Attention: Application Examiner / Review Engineer
Subject: Requesting Class II permissive change

The purpose of this letter is to request a Class II Permissive change for FCC ID: WR9EBSTAT3LT01,
Original grant date: August 22, 2016. Applicant: Ecobee Inc.

The major change filed under this application is the LCD Display

Figure 1
Previous Metal Shield around LCD

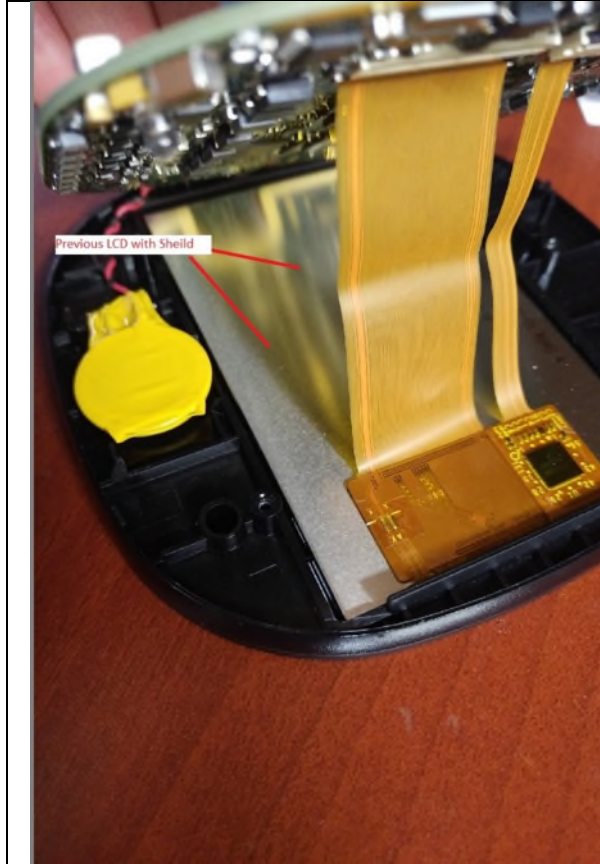
The metal shield around the LCD display was removed for cost. See the modification in Figures 1 and 2 below. There are no other hardware, schematic or block diagram changes to the product. RSE measurement is to demonstrate for the new enclosure.
